# CITY OF ALBUQUERQUE

**RE: Ceja Vista Unit 1**  
**Engineer's Certification Date: 12/14/20**  
**Engineer's Stamp Date: 10/04/19**  
**Hydrology File: P09D002F**  
**CPN # 614193, 614194, & 614195**

Based on the Certification received 12/14/20 and site visit on 01/22/20, this certification is **not** approved in support of ROFG/SIA by Hydrology. As noted the Release of Financial Guarantee includes the following Work Order projects: 614193 (Ceja Vista Unit 1 Phase I Off-Site Infrastructure Improvements), 614194 (Valle de Atrisco On-Site Infrastructure), & 614195 (Ceja Vista Unit 1 Phase II Infrastructure Improvements).

CPN # 614193

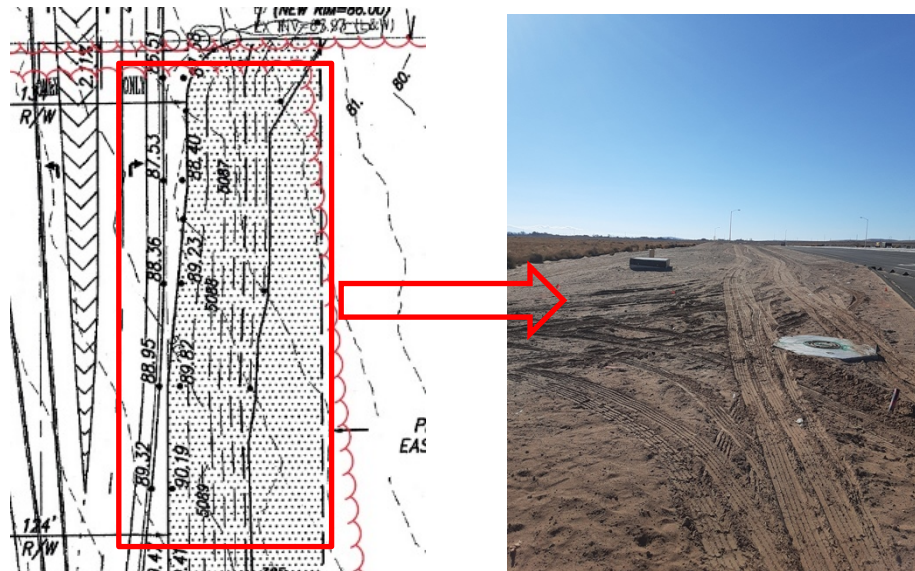
1. Please include the as-built grading done on the east side of the road in this certification.

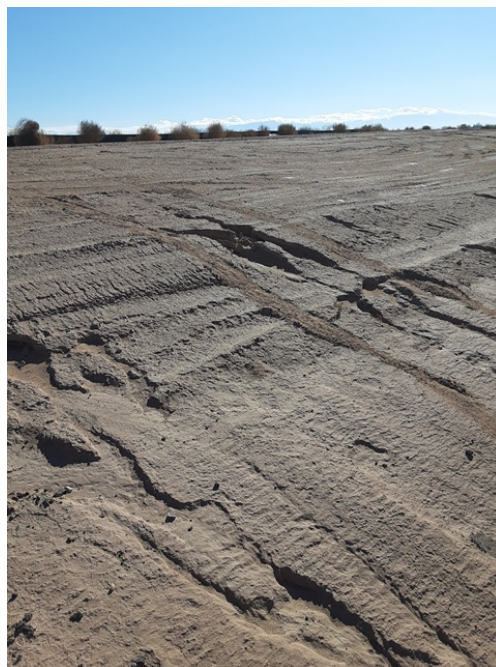
2. Please remove the tumbleweeds and the silt from the concrete channel.

3. Please correct the earth side slopes of the channel. The max design slope was to be 10:1 but it appears that this is steeper and the slope is unstable and is eroding into the concrete channel. Also, please include the as-built grading done along the concrete channel and access road in this certification.

CPN # 614194

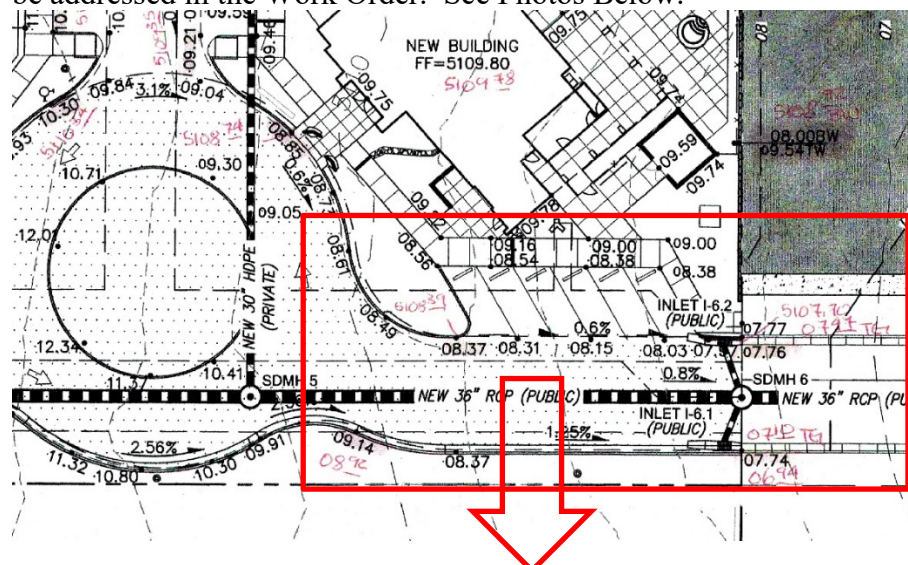
4. It also appears that the pond was not built per the construction plans. There was not berm built around the pond, the emergency spillway does not appear to be built, and section A-

A along the west side of the channel and pond was not built. It does not seem that the pond was actually as-built surveyed. Please include all as-built grading in this certification.

5. As shown on the certified Grading & Drainage Plan, it stated that grades at the entrance of the Apartments will drain to the Type A inlet at the entrance. However, as I was leaving I notice some water that the contractor had used to wash something. But this drainage did not flow as designed or as you had certified. This did pond and drainage across the drive but it still did not flow the Type A inlet on the other side. It appears that both Type A inlets were installed as a waterblock to the site so this drainage will have to be addressed in the Work Order. See Photos Below.

CPN # 614195

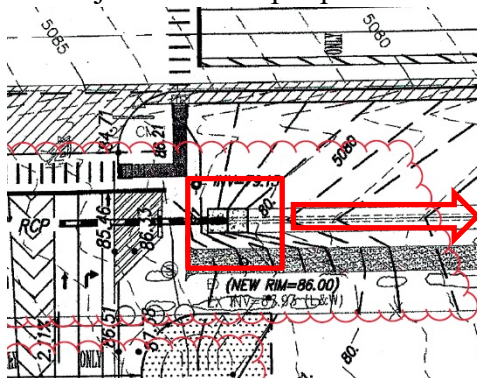
6. Please just add the rip rap on the as-built.
